TRANS/WP.29/GRSP/2002/6  
1 March 2002

World Forum for Harmonisation of Vehicle Regulations (WP.29)

PROPOSAL FOR DRAFT AMENDMENTS TO REGULATION No. 95  
(Lateral protection collision)

Transmitted by the Expert from the European Enhanced  
Vehicle-safety Committee (EEVC)

Blocks 1 & 3  
Figure 2a

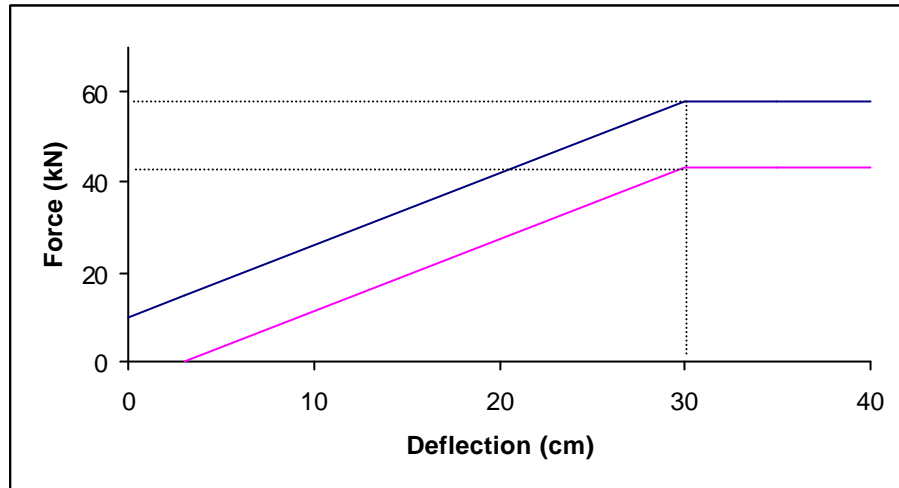
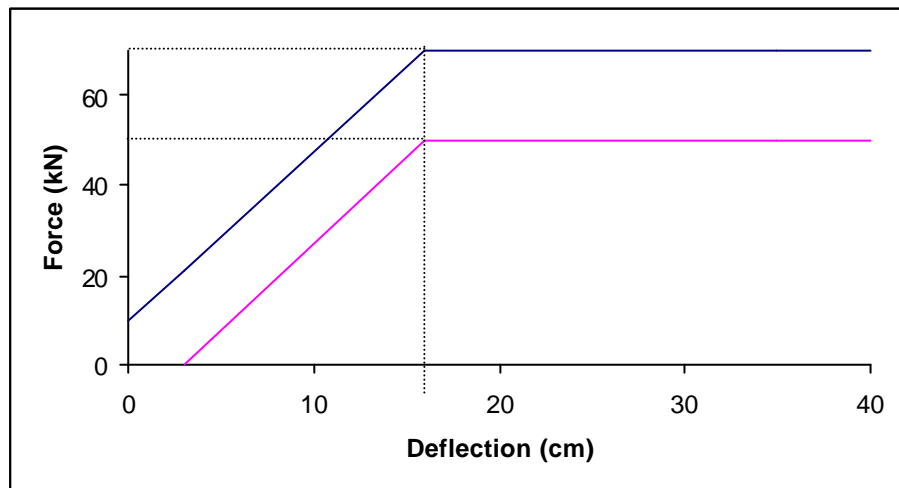
- 2.1.5.10. The dissipated energy  $\frac{1}{2}$  against blocks 1 and 3 during the test shall be equal to  $9.5 \pm 2$  kJ for these blocks.
- 2.1.5.11. The dissipated energy against blocks 5 and 6 during the test shall be equal to  $3.5 \pm 1$  kJ for these blocks.

[NOTE: the values of energy absorption for only blocks 1&3 and 2 differ from that in the existing Regulation 95]
